ENGINEER'S SEAL	8001 FIJI COURT BRUNO RESIDENCE	DRAWN BY WCWJ
DAVID SOULE NEW MEXICO REGISTERED PROFESSIONAL ENGINEER 2/1/17	GRADING AND DRAINAGE PLAN	DATE 2-01-17
DAVID SOULE P.E. #14522	Rio Grande Engineering 1806 CENTRAL AVENUE SE SUITE 201 ALBUQUERQUE, NM 87106 (505) 872-0899	21701-LAYOUT-1-10-17
		SHEET #
		JOB # 21701

ENGINEER'S SEAL DAVID SOULE NEW MEXICO 14522 REGISTERED PROFESSIONAL ENGINEER	8001 FUJI COURT BRUNO RESIDENCE	DRAWN BY WCWJ
	GRADING AND DRAINAGE PLAN	DATE 1-12-17
1/13/17	 Rio Grande Engineering 1606 CENTRAL AVENUE SE SUITE 201 ALBUQUERQUE, NM 87106 (505) 872-0999	21701-LAYOUT-1-10-17
DAVID SOULE P.E. #14522		SHEET # —
		JOB # 21701

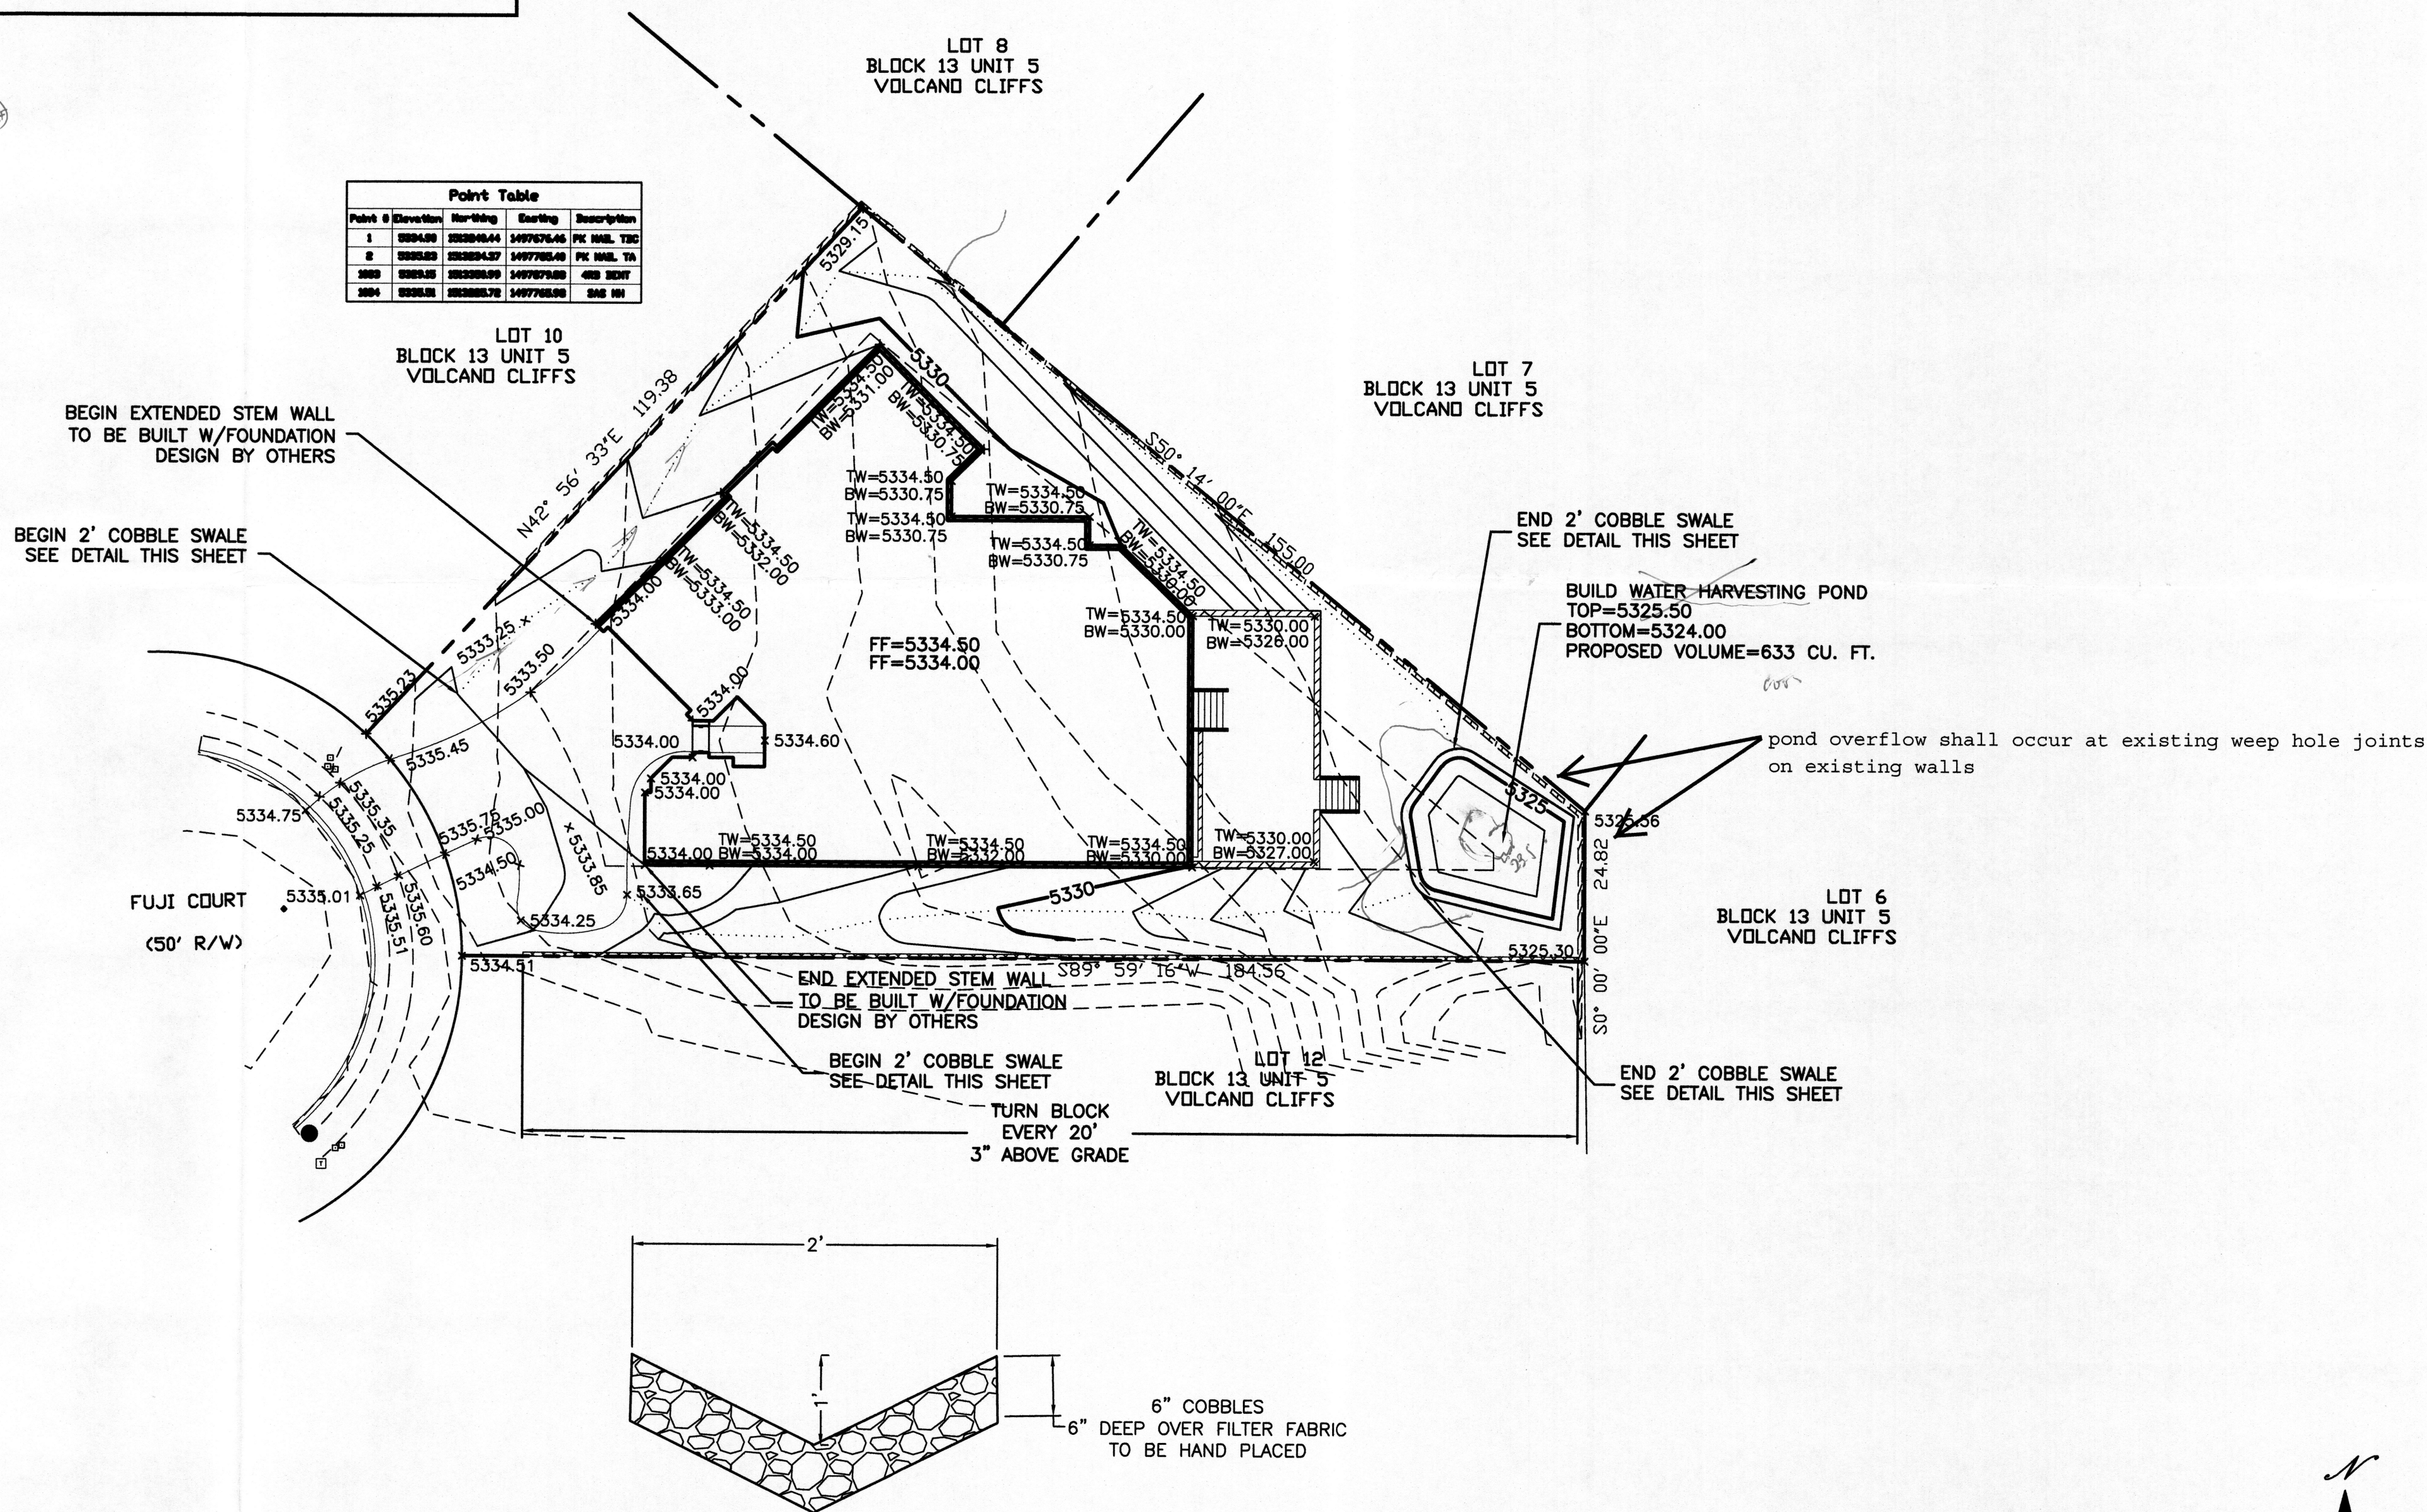
for historic flow path to adjoining lots
retain at least 50% of 100yr, 24hr vol. or increase (1089)
need DMP pages
